Byron Station, Units 1 and 2
Facility Operating License Nos. NPF-37 and NPF-66
NRC Docket Nos. STN 50-454 and STN 50-455

Subject: Core Operating Limits Report for Byron Station, Unit 1 Cycle 11
Core Operating Limits Report for Byron Station, Unit 2 Cycle 9

Subject Byron Unit 1 Cycle 11 Core Operating Limits Report in ITS Format and W(z) Function

Subject Byron Unit 2 Cycle 9 Core Operating Limits Report in ITS Format and W(z) Function

Figure 2.6.1.a: K(Z) - Normalized Fq(Z) as a Function of Core Height (Assembly BU \leq 4000 MWD/MTU)

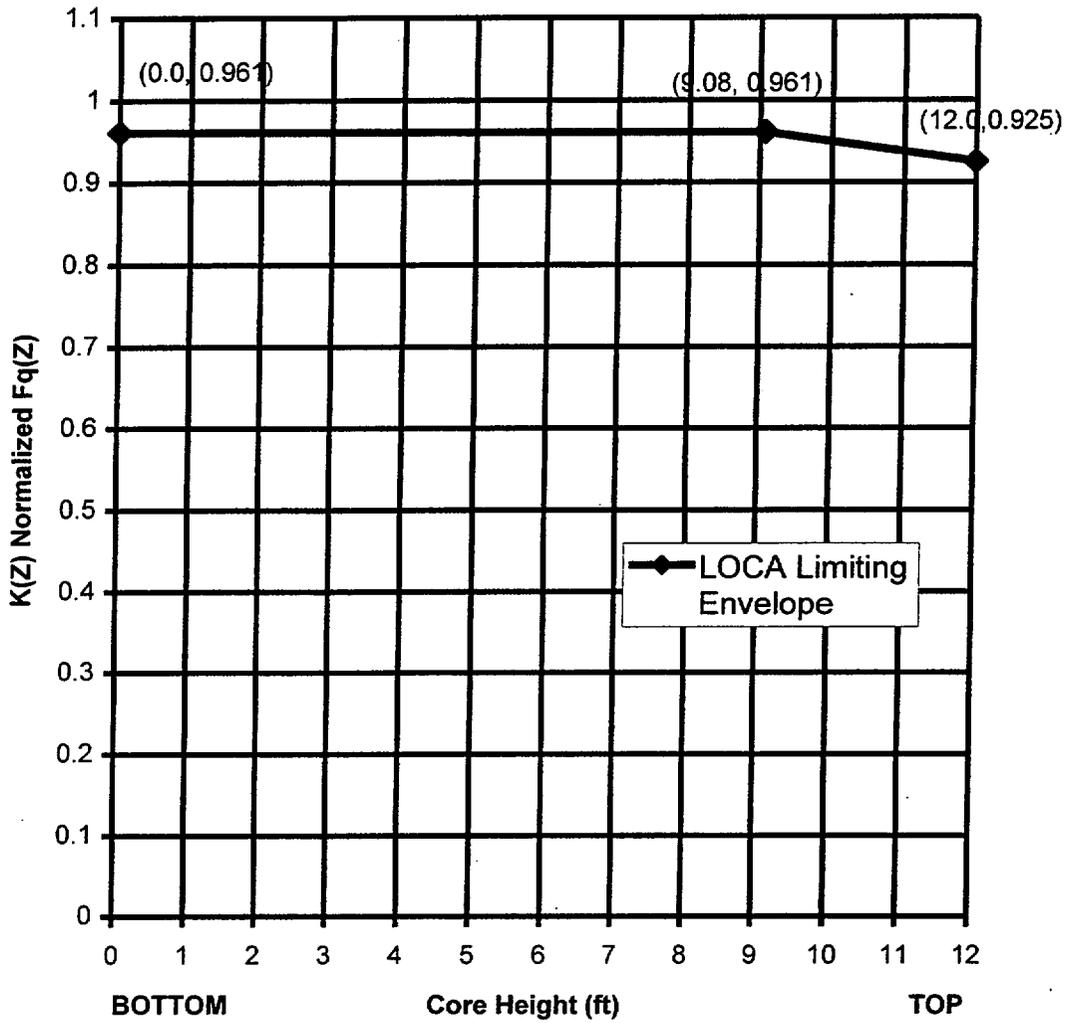
Purpose of Information: **Revision 2 of this TODI supersedes TODI NFM0000119, Rev. 1. Revision 2 incorporates the correct K(Z) curve for Assembly Burnup ≤ 4000 MWD/MTU case.** This COLR incorporates the BY1C11 cycle-specific parameters and the Expanded COLR format which includes Reactor Core Safety Limits, Reactor Trip System Instrumentation, and RCS DNB Parameters. Furthermore, the analytical limit of 224 rods out position is included. Byron Station is requested to perform a Plant Review of this document. Upon completion of the Plant Review, Byron Station is to transmit the COLR portion to the Nuclear Regulatory Commission pursuant to Technical Specification 5.6.5. Please provide NFM (Erich Wurz) with a copy of Byron Station's completed Plant Review and COLR submittal to the NRC.

Figure 2.6.1.a: $K(Z)$ - Normalized $Fq(Z)$ as a Function of Core Height (Assembly Average ≤ 4000 MWD/MTU)

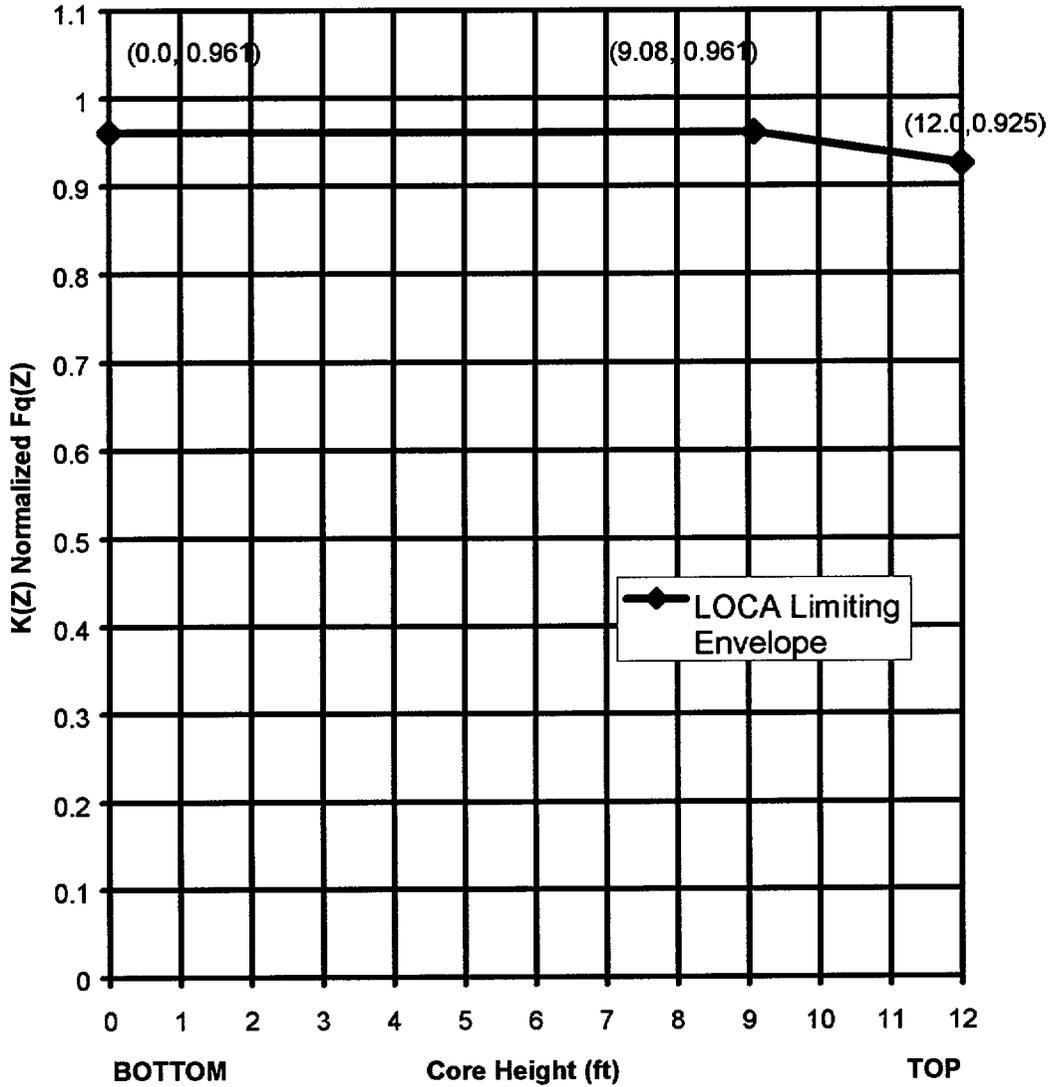
Additionally, an error has been identified in the COLR for Unit 2, Cycle 9. The COLR, on page 9 of 18, had an incorrect figure for the K(Z)-normalized Fq(Z) curve. There were two identical figures (Figure 2.6.1) for the >4000 MWD/MTU assembly average burnup case. There should have been one Figure 2.6.1 for the >4000 MWD/MTU case and one Figure 2.6.1.a, which represents other K(Z) limits for assembly average burnup ≤ 4000 MWD/MTU. This error occurred when the COLR was revised on June 2, 2000, to incorporate the Expanded COLR format. We are providing a revised COLR for Unit 2, Cycle 9 with the correct pages.

Purpose of Information: **Sequence 2 of this NDIT supersedes Sequence 1. Sequence 2 revises Page 9 to include the correct Figure 2.6.1.a for the K(z) curve with assembly average burnup \leq 4000 MWD/MTU.**
